OFFSHORE POWER SYSTEMS

DOCKET NO. STN 50-437

INSTRUCTIONS FOR ENTERING AMENDMENT NO. 28

IN THE PLANT DESIGN REPORT

CONTAINMENT MODIFICATIONS REQUIRED FOR 80 PSIG CAPABILITY

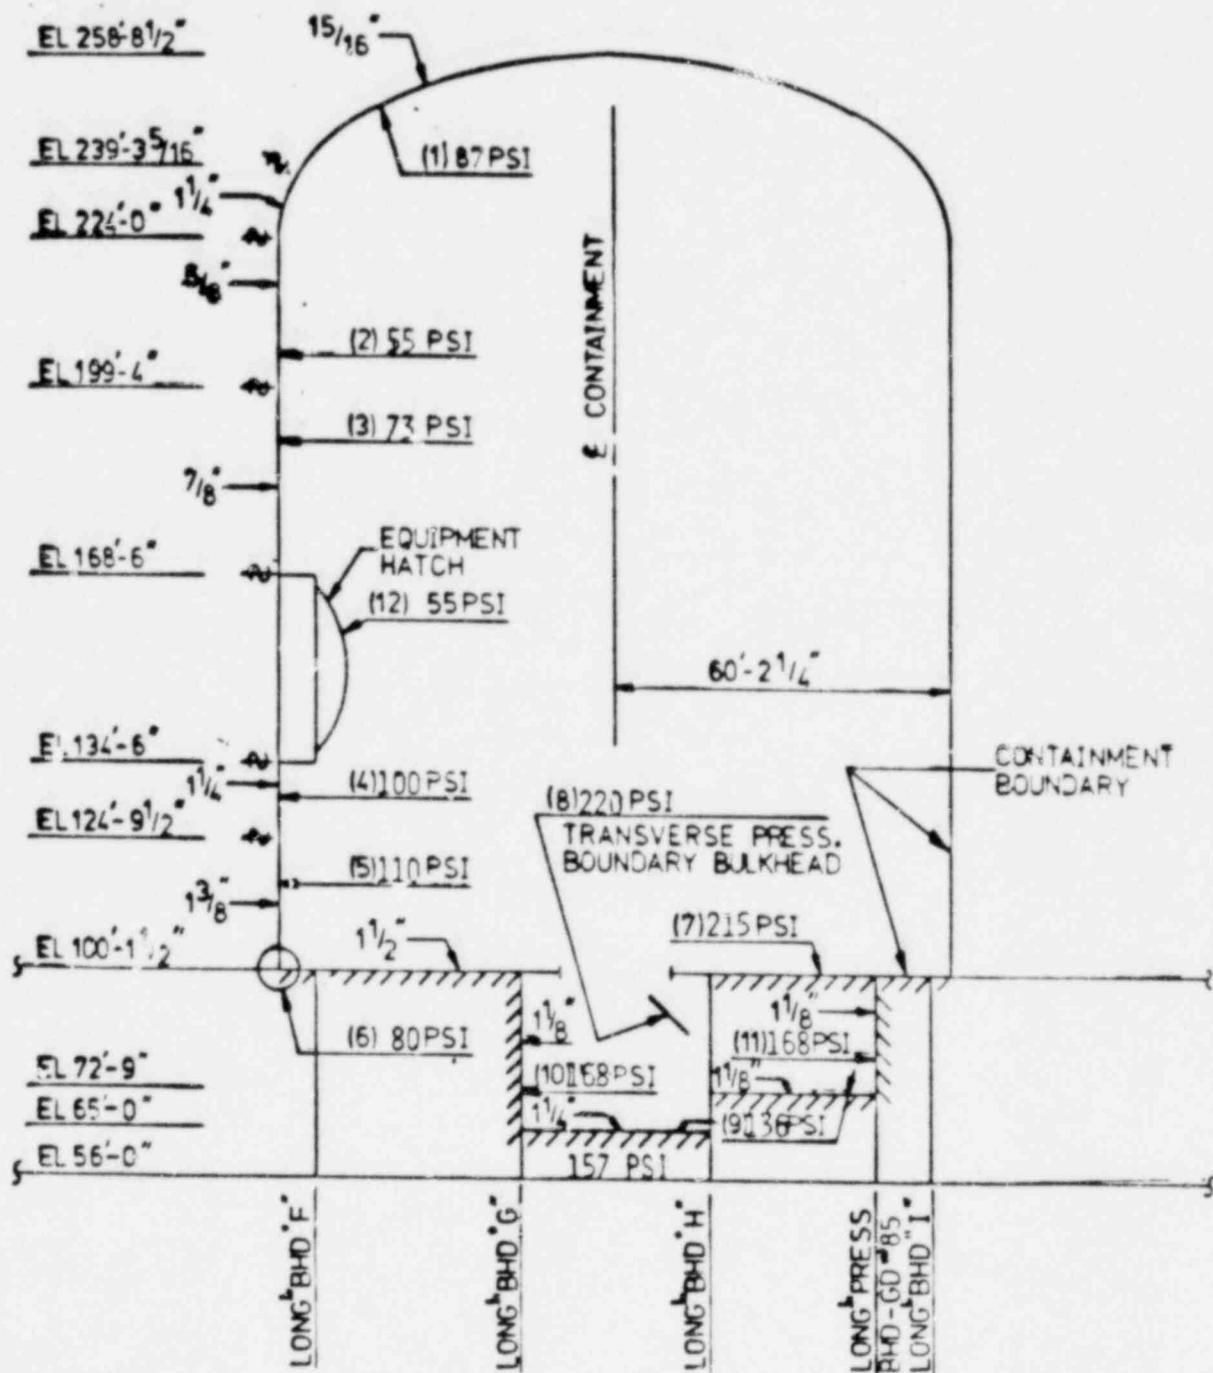
1. INCREASE THICKNESS OF SHELL (ELEVATION 199'4" TO 224'0") FROM 5/8" TO 1".
2. INCREASE THICKNESS OF SHELL (ELEVATION 162'2" TO 199'4") FROM 7/8" TO 1".
3. INCREASE CAPABILITY OF EQUIPMENT HATCH COVER BY ONE OF THE FOLLOWING:
  - A) INCREASE THICKNESS FROM 1-3/8" TO 1-3/4".
  - B) ADD STIFFENERS TO PREVENT BUCKLING.
  - C) REVERSE ORIENTATION SO THAT PRESSURE ON COVER IS INTERNAL PRESSURE.
